LAND USE APPLICATION COMPLETENESS REVIEW

Subject Property: 1105 Front Street NE

Reference Nos.: 24-106451-PLN (Class 3 Site Plan Review, Tentative Subdivision Plan, Class 1 & 2 Adjustment, Class 2 Driveway Approach Permit)

**TENTATIVE PLAT
 THE CANNERY
 FUND
 SALEM, OREGON**

L104

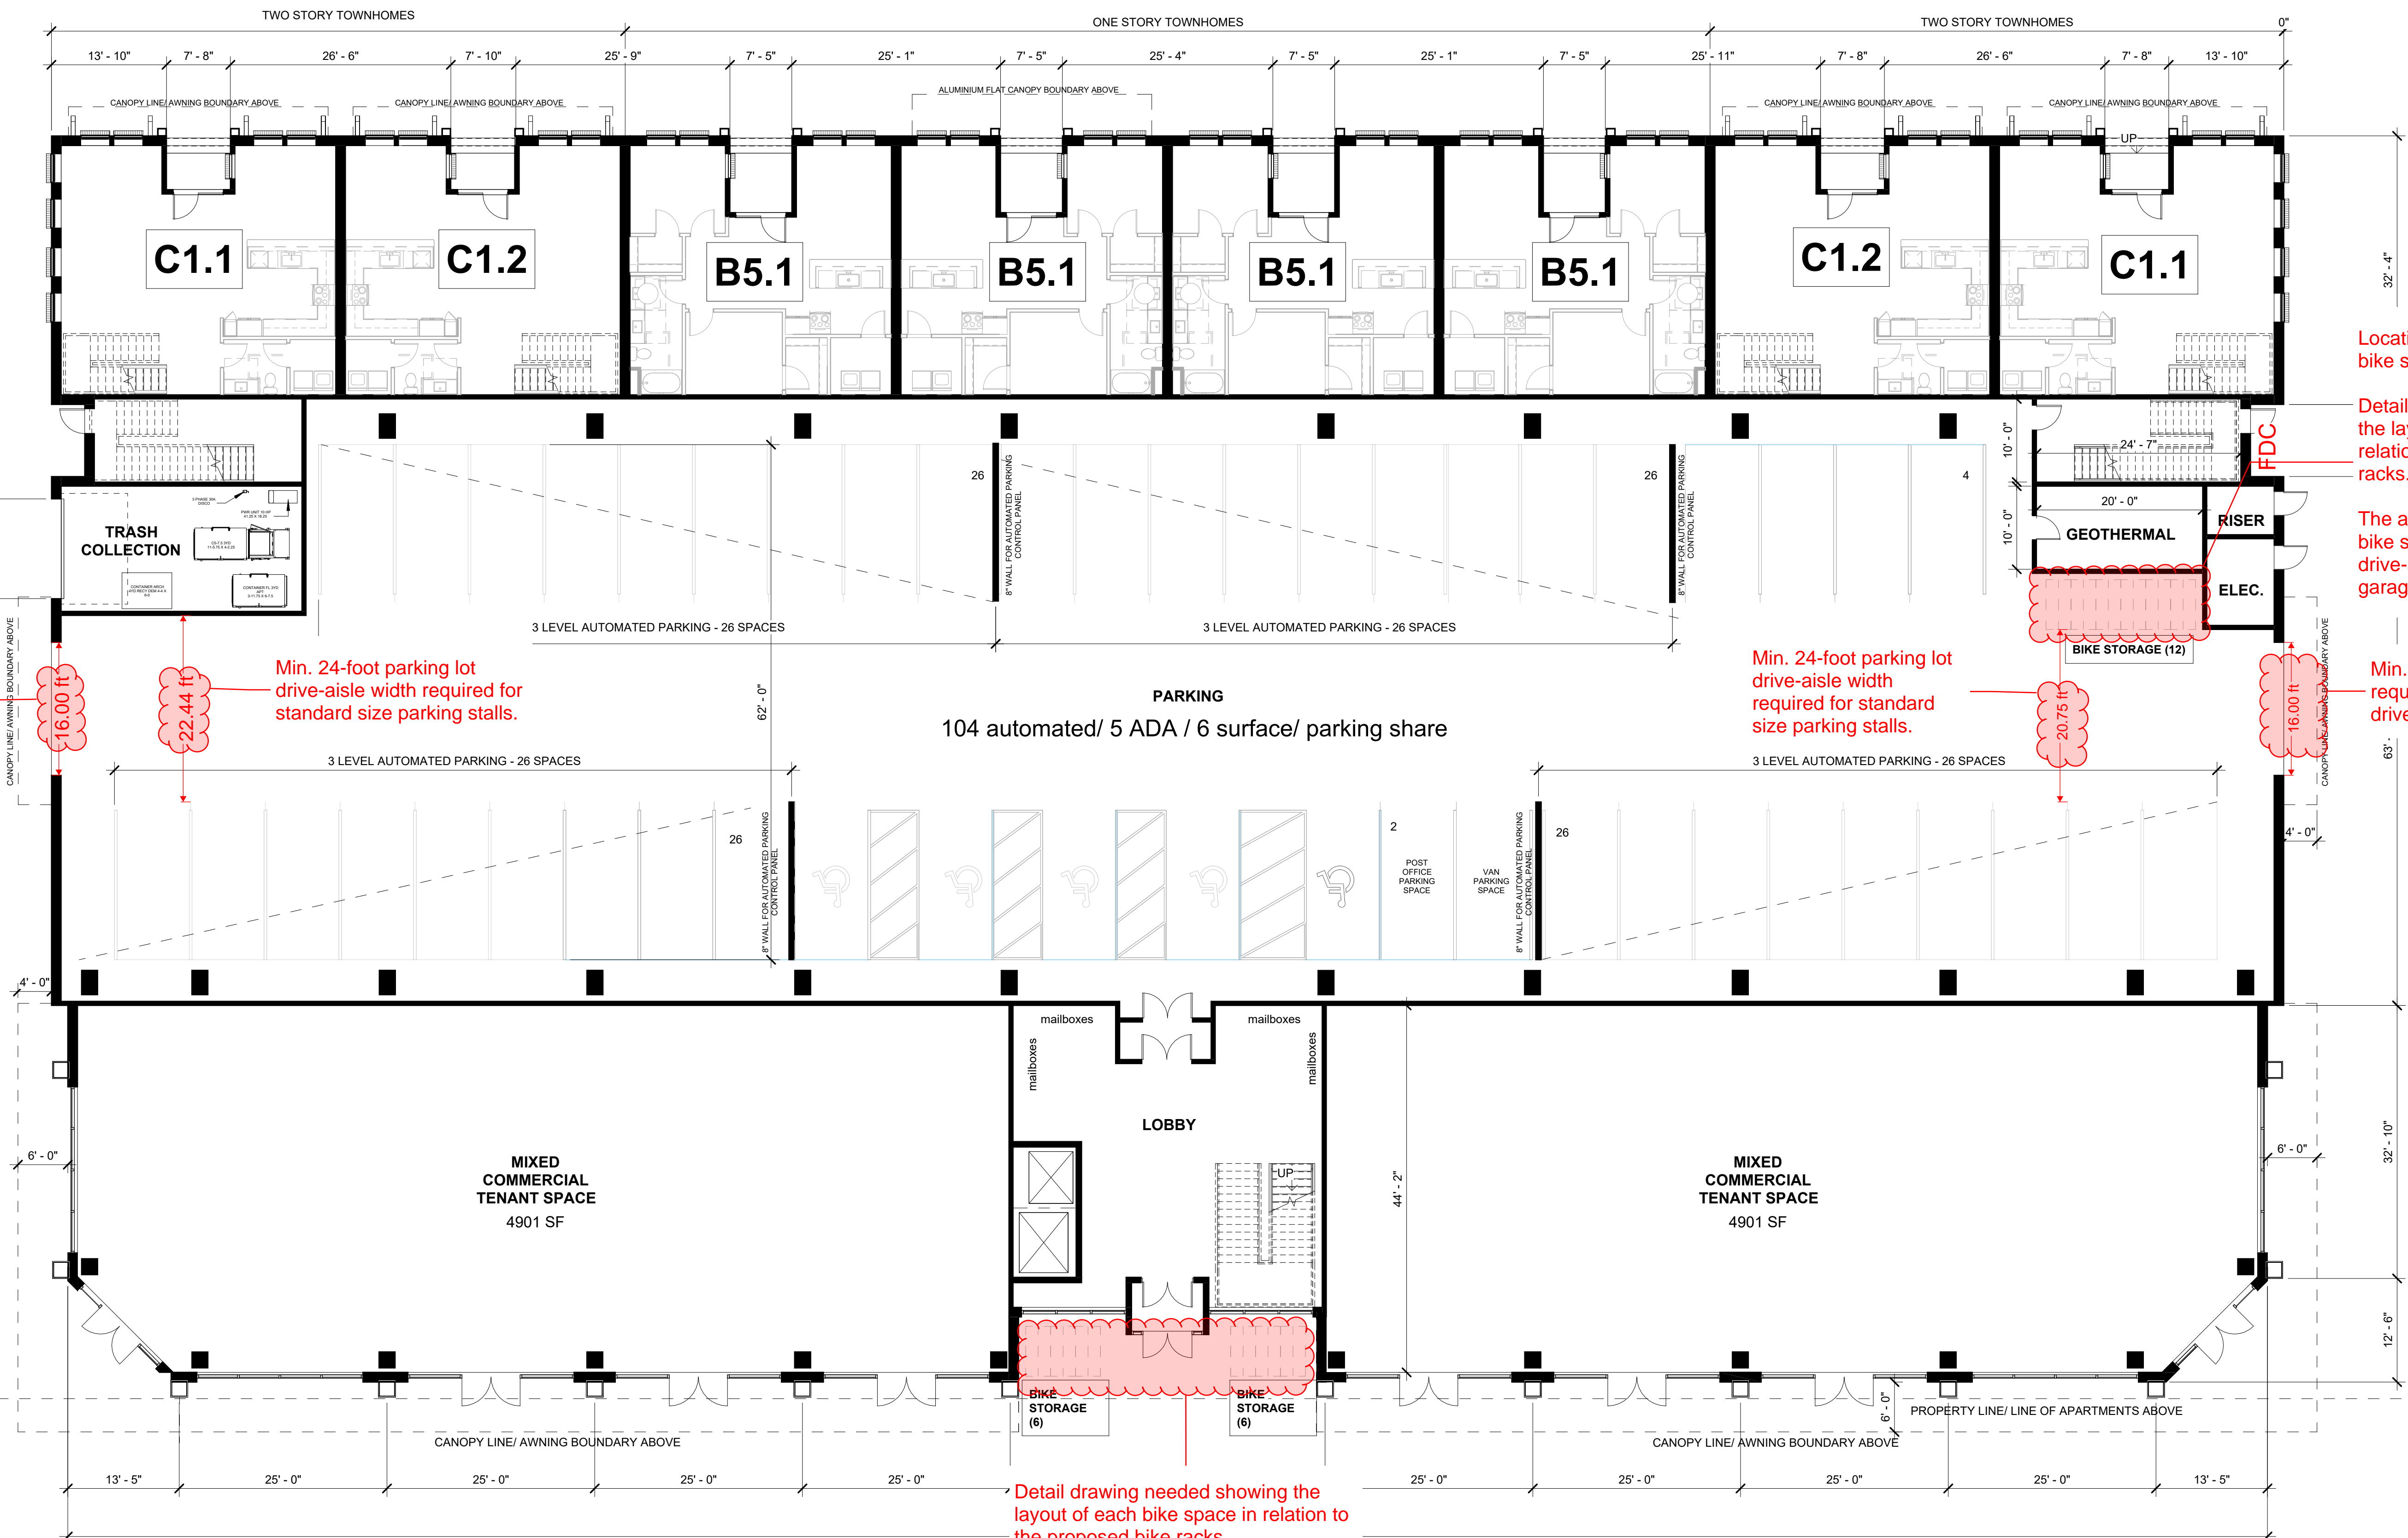
Additional Standards for New Surface Parking More than One-Half Acre in Size:
 -The new surface parking lot area is more than one-half acre in size. Therefore, the additional new large parking lot landscaping standards adopted in response to the State's Climate Friendly & Equitable Communities (CFEC) administrative rules apply.

The additional landscaping standards are included under **SRC 806.035(n)**.

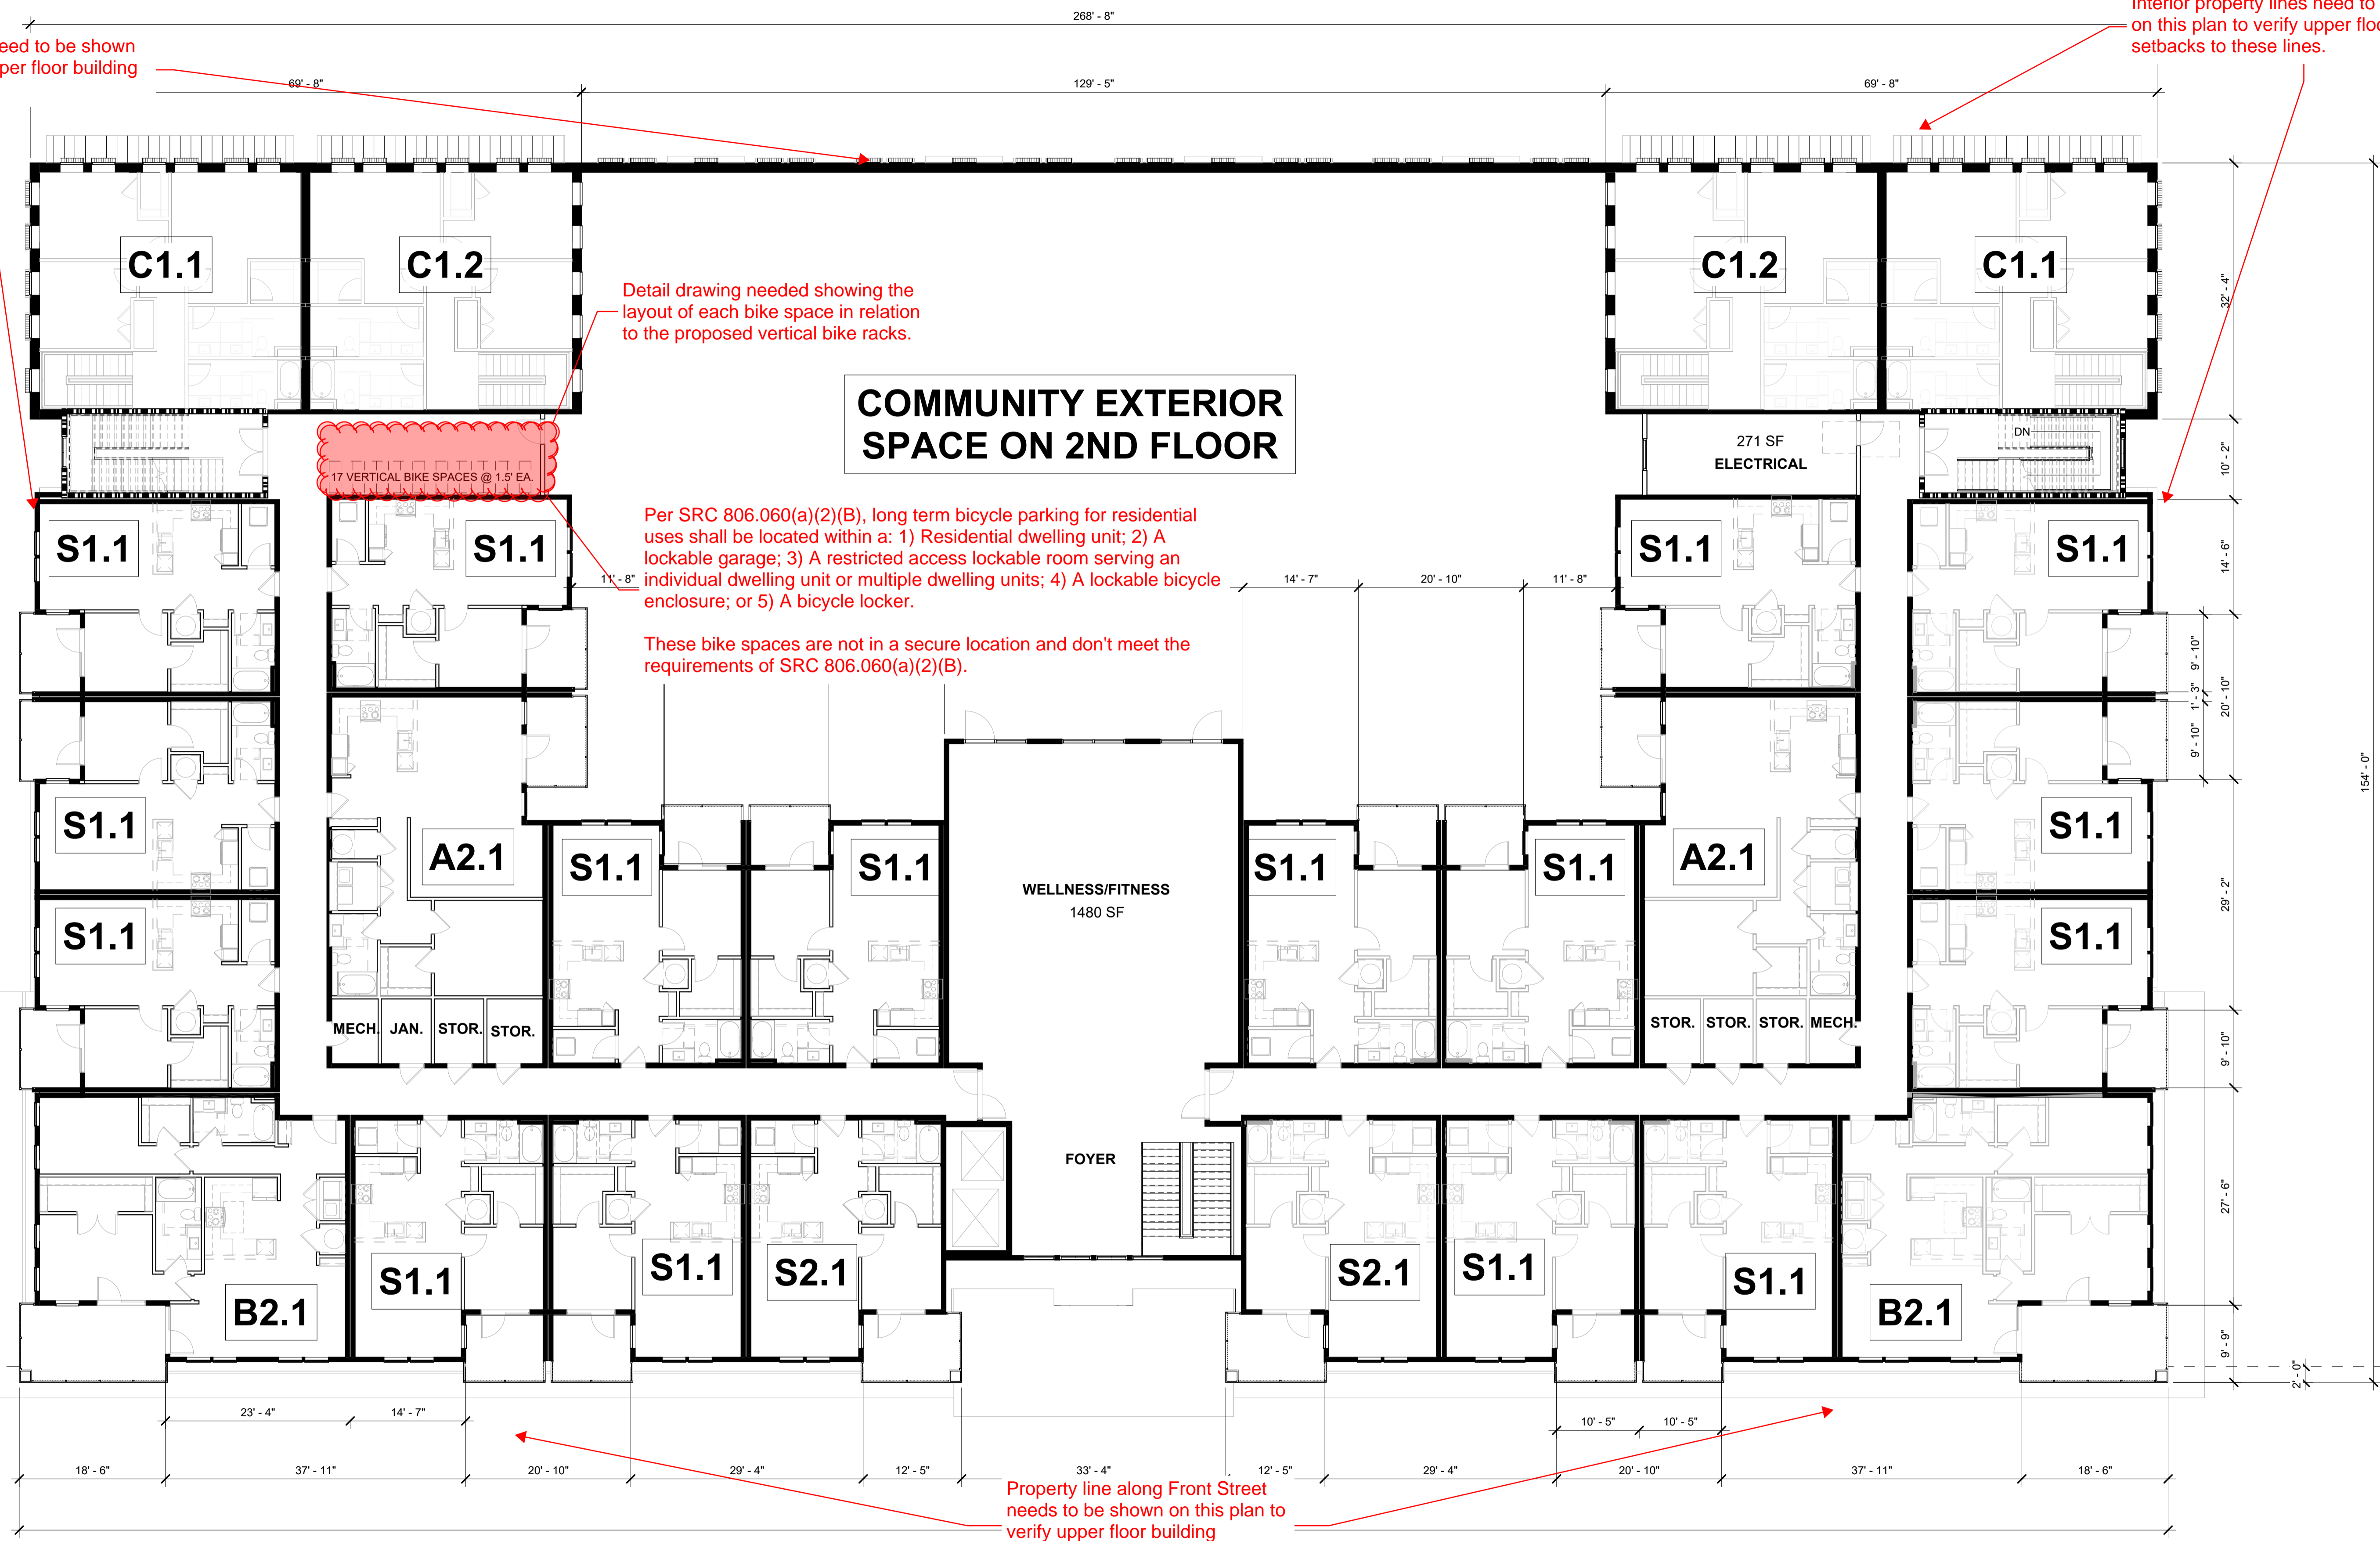
Ground Floor Building Height
 SRC 536.015(g) - Table 536-6 requires buildings with ground floors on primary streets to have a minimum ground floor height of 10 ft. For purposes of this stand ground floor height is measured from the floor to the ceiling of the first floor. The applicant's written statement indicates that the ground floor height of the building is 18 feet. However, in review of the building elevations it looks like the 18-foot height is measured from the floor of the first floor to the floor of the second floor. Confirmation is needed regarding the ground floor height of Buildings 1, 2, and 3 measured from floor to ceiling of the first floor.

Min. 22-foot opening required for two-way driveway.

Min. 24-foot parking lot drive-aisle width required for standard size parking stalls.

Location of bike racks don't meet bike standards of SRC 806.060.

Detail drawing needed showing the layout of each bike space in relation to the proposed bike racks.

The access aisle to get to the bike spaces is located in the drive-aisle into the parking garage.
